**CITY OF KIRKLAND**  
**Planning and Building Department**  
123 Fifth Avenue, Kirkland, WA 98033  
425.587-3600 - [www.kirklandwa.gov](http://www.kirklandwa.gov)

**To:** Design Review Board  
**From:** Tony Leavitt, Associate Planner  
**Date:** July 22, 2016  
**File No.:** DRV16-01636  
**Subject:** LENNAR TOTEM LAKE APARTMENTS  
CONCEPTUAL DESIGN CONFERENCE

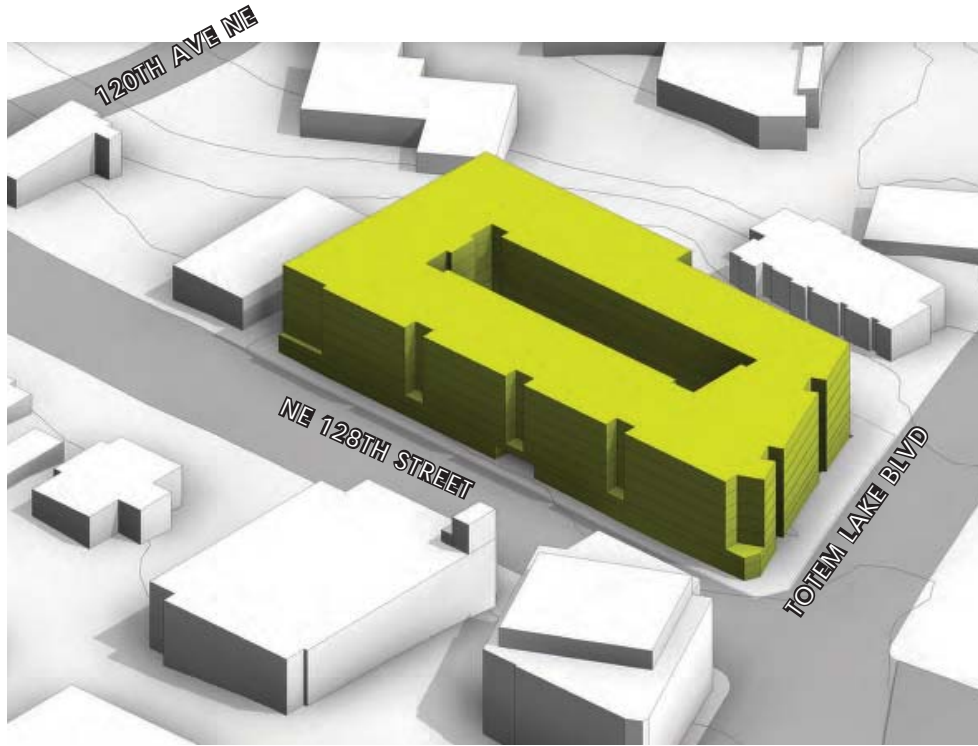
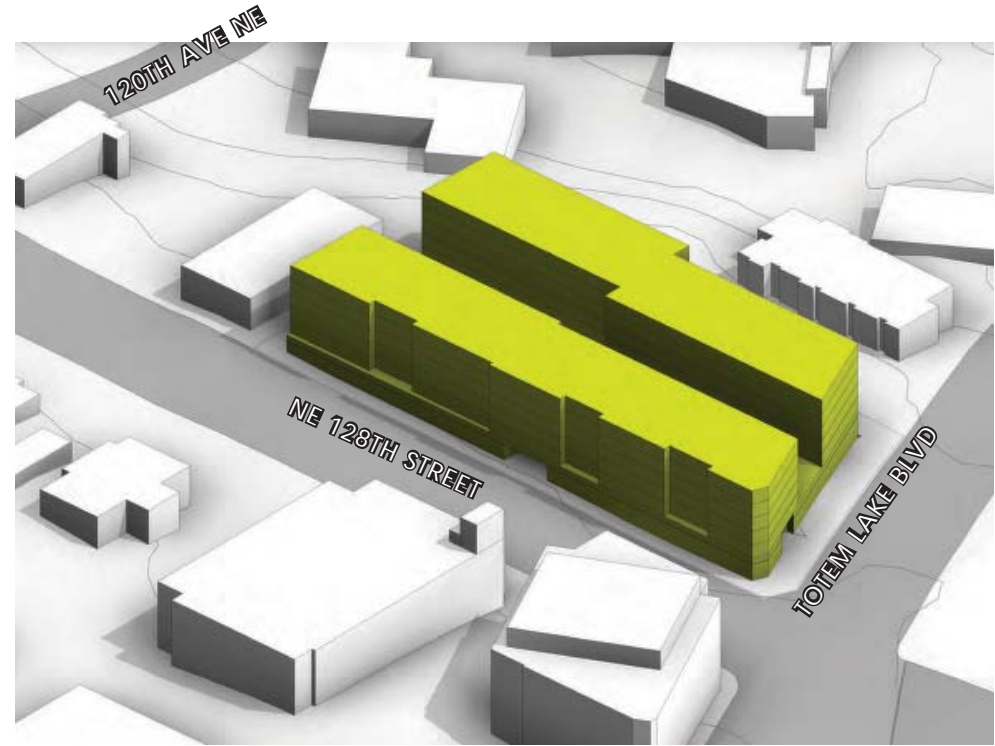
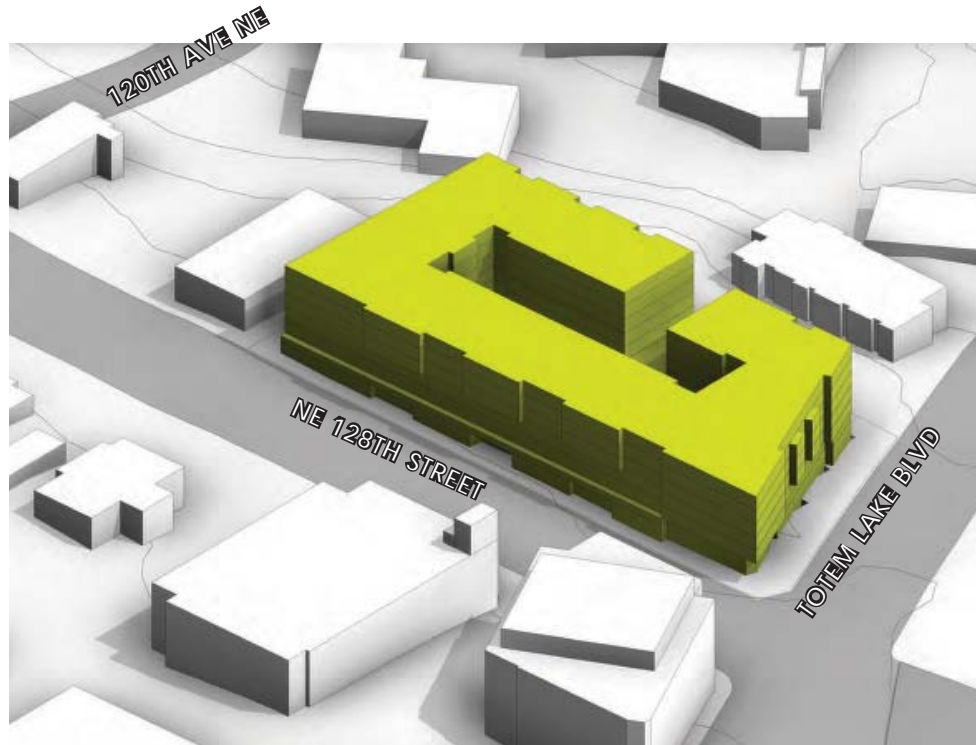
1. What are the key vantages of the project?
2. Identify appropriate mitigation techniques for building massing of the proposed buildings. Possible techniques include vertical and horizontal modulation, corner treatment, and roof forms. The applicant has provided several massing schemes including a preferred option (Option 3) for the DRB's review and comment (see Attachment 2).
